ABINGTON TOWNSHIP

BOARD OF COMMISSIONERS WORKING SESSION

- a. Presentation of the Preliminary/Final Major Subdivision and Land Development for LD-23-03 - 1583 Rothley Avenue.

RE: Executive Summary for LD-23-03-1583 Rothley Avenue
PARID: 30-00-60076-00-5/ TMID: 30200 002
PARID: 30-00-60072-00-9/ TMID: 30200 003
Preliminary/Final Major Subdivision & Land Development Plans Review (2nd Submission)

COVER SHEET
OF
1583 ROTHLEY AVENUE
PREPARED FOR
DOLSON, LLC
ABINGTON TOWNSHIP, MONTGOMERY COUNTY, PA.

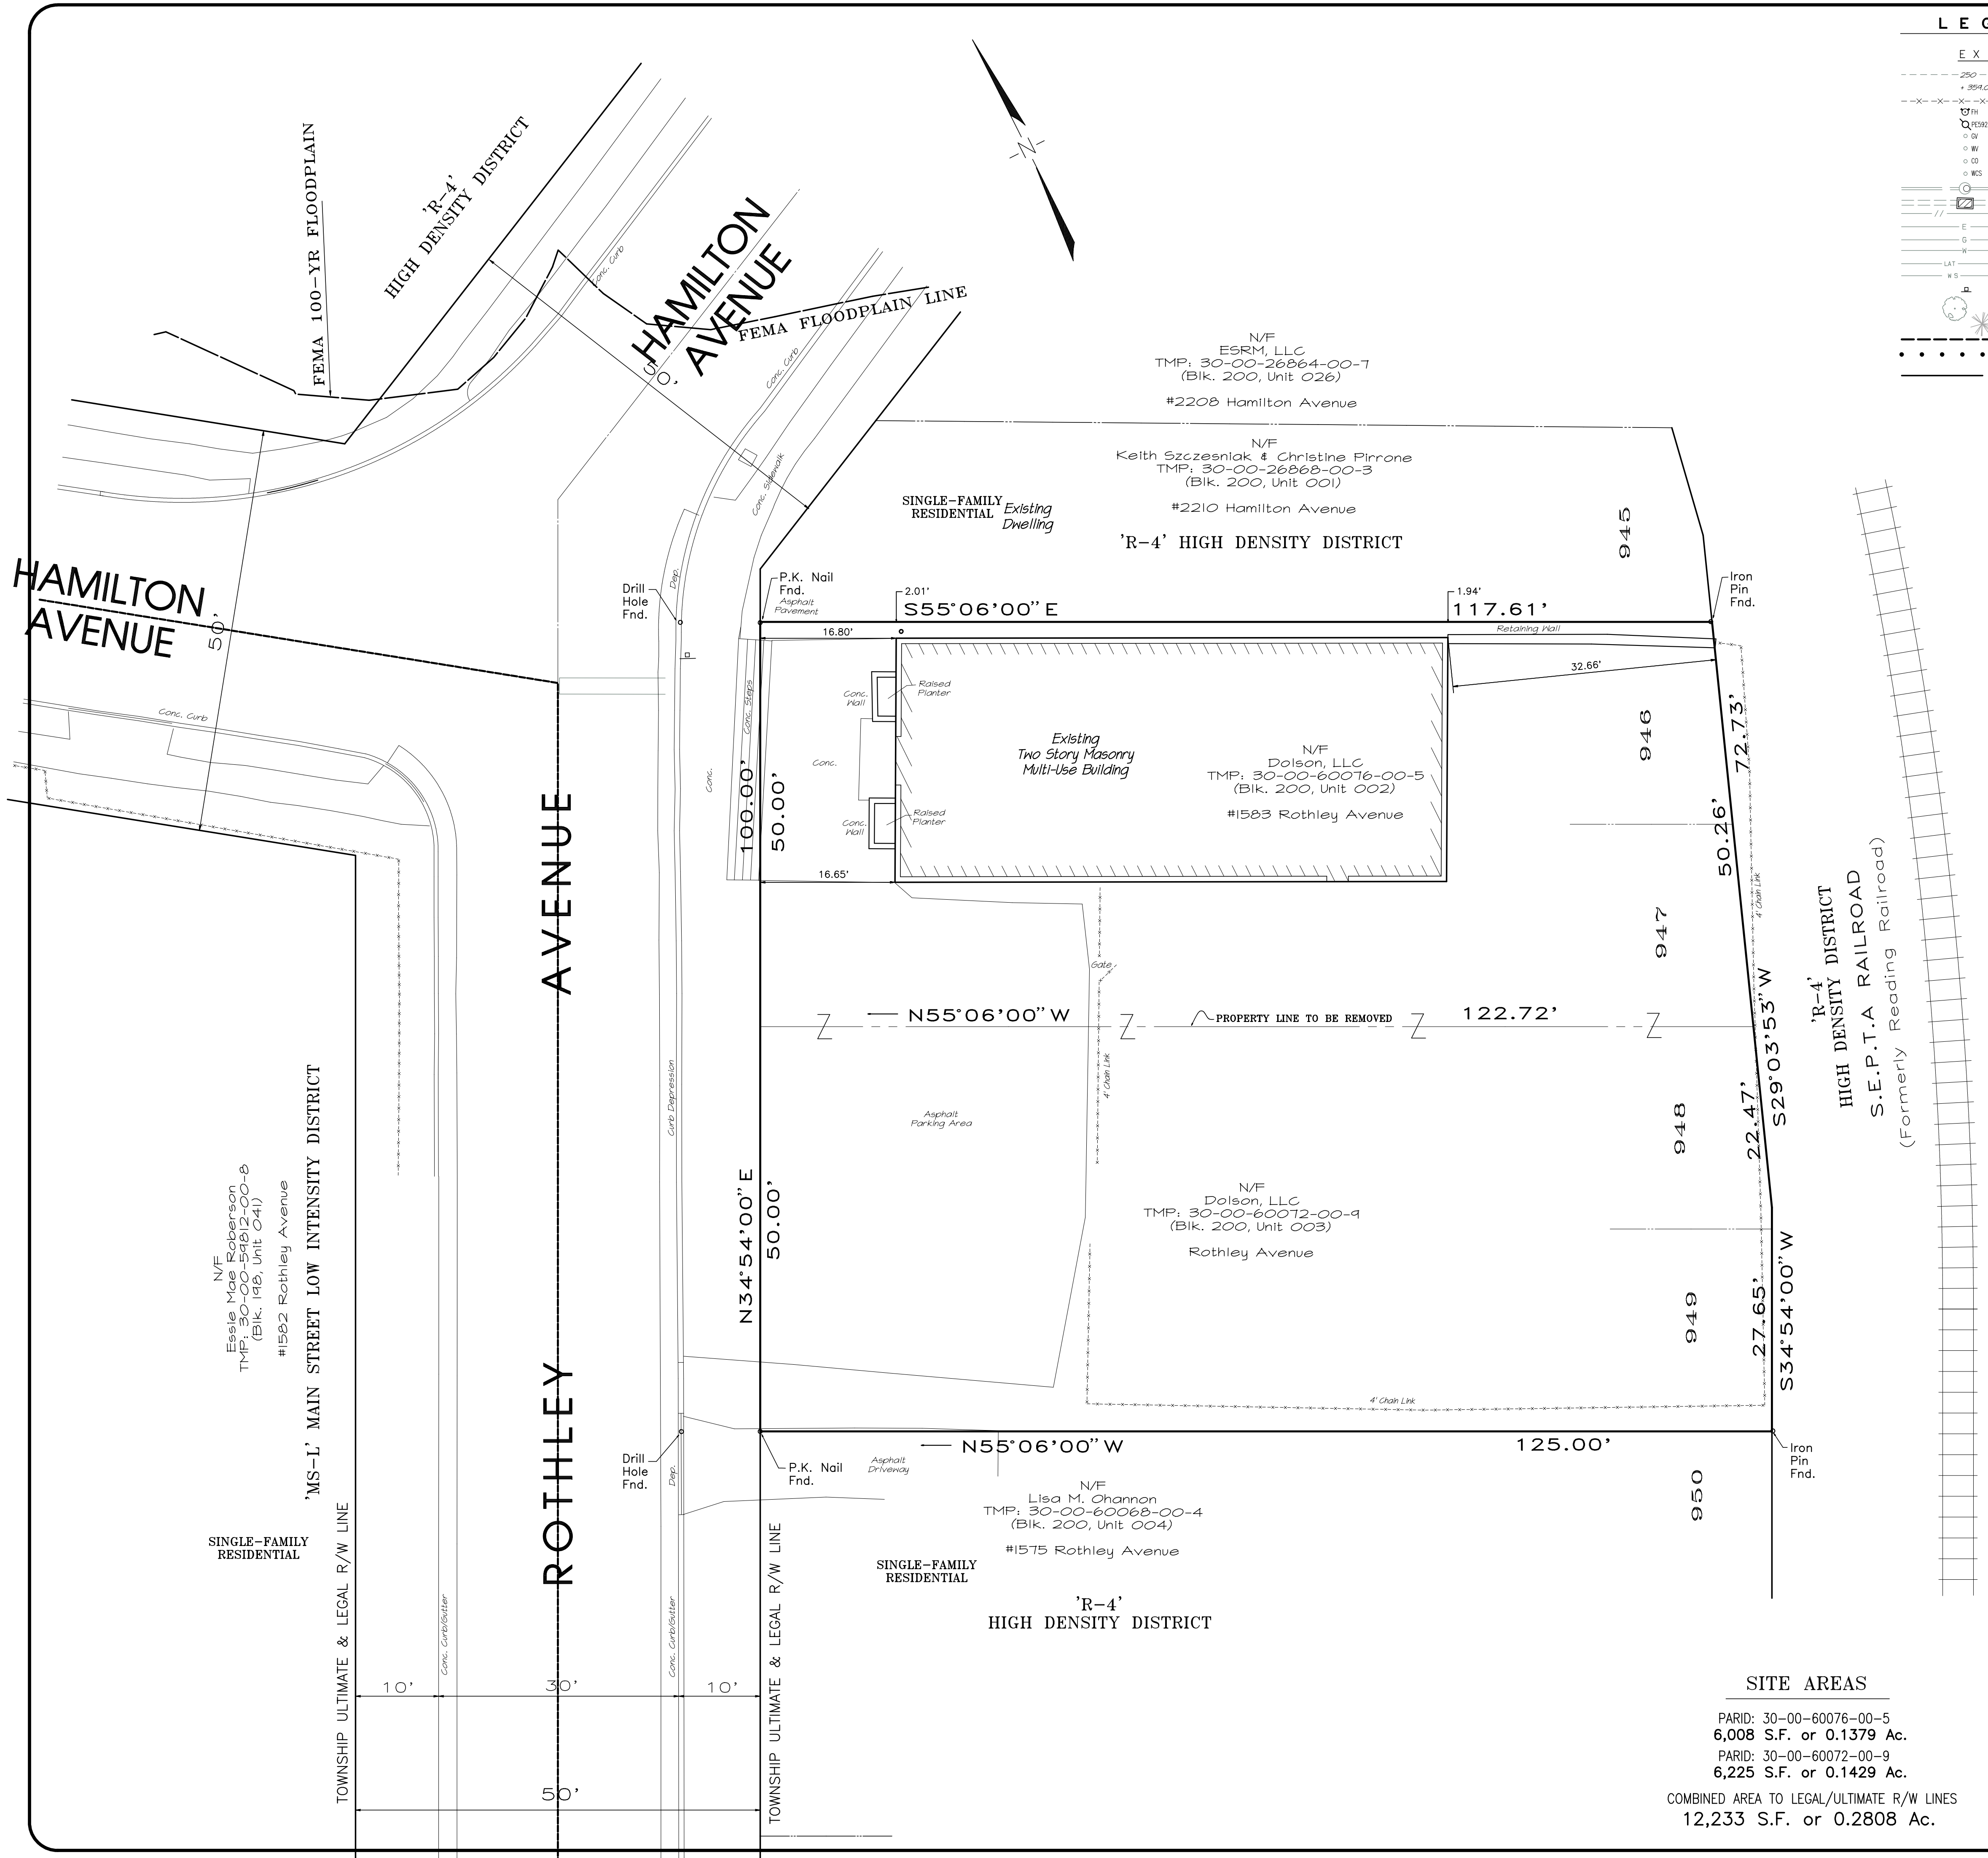
25. **Per §146-12.B.(5) – Record Plan Seals** – The impressed seal of the Township Engineer shall be provided on the Cover Sheet (Sheet 1).

26. **Per §146-12.E – Recording notations** – The plans shall provide the recording notations as indicated in this Code Section on the Cover Sheet (Sheet 1).

25. **Per §146-12.B.(5) – Record Plan Seals** – The impressed seal of the Township Engineer shall be provided on the Cover Sheet (Sheet 1).

26. **Per §146-12.E – Recording notations** – The plans shall provide the recording notations as indicated in this Code Section on the Cover Sheet (Sheet 1).

The notations as indicated in §146-12.E.(2) thru (6) shall be included on the Cover Sheet (Sheet 1).

LOT CONSOLIDATION PLAN
OF
1583 ROTHLEY AVENUE
PREPARED FOR
DOLSON, LLC
ABINGTON TOWNSHIP, MONTGOMERY COUNTY, PA.

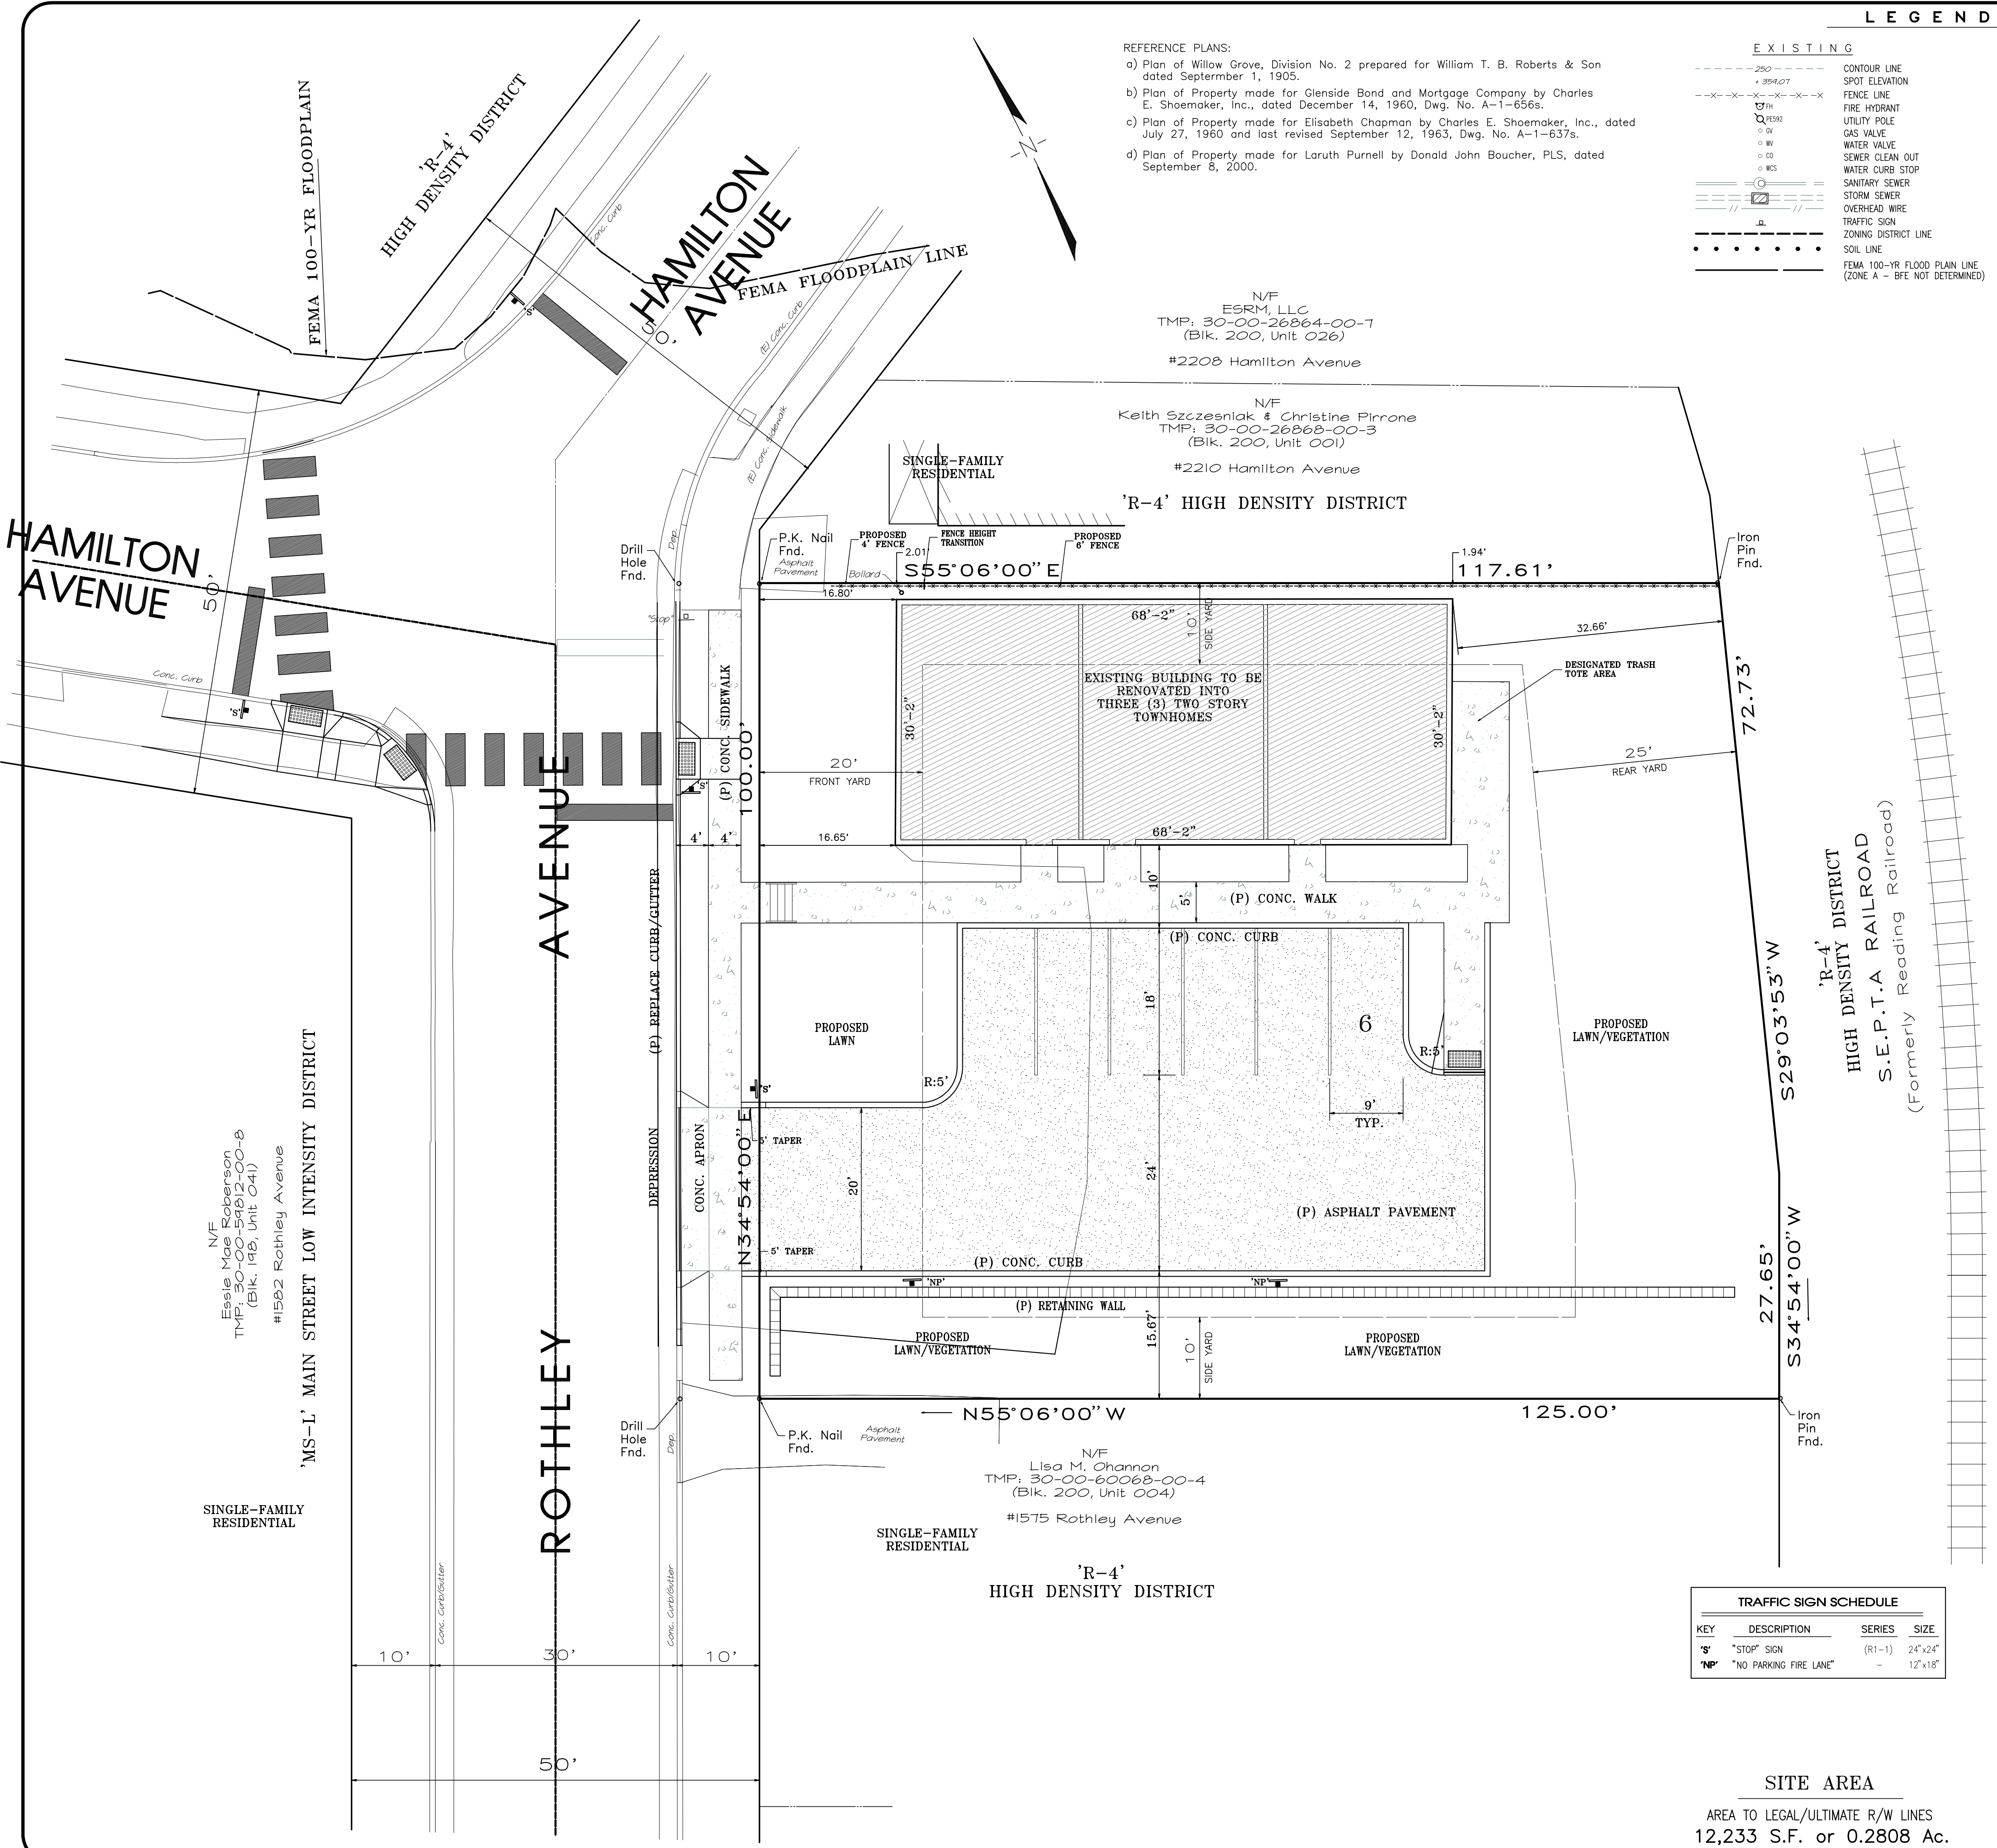
Based on the notes on the Subdivision Plan (Sheet 2), the vertical datum on the plans is based on NAVD 1988. The elevations shall be based upon the sanitary sewer datum of Abington Township per this Code Section. The Applicant shall either provide the elevations based on the sanitary sewer datum of Abington Township; or provide a conversion reference note from the NAVD1988 to the Abington Township sanitary sewer datum on the plans.
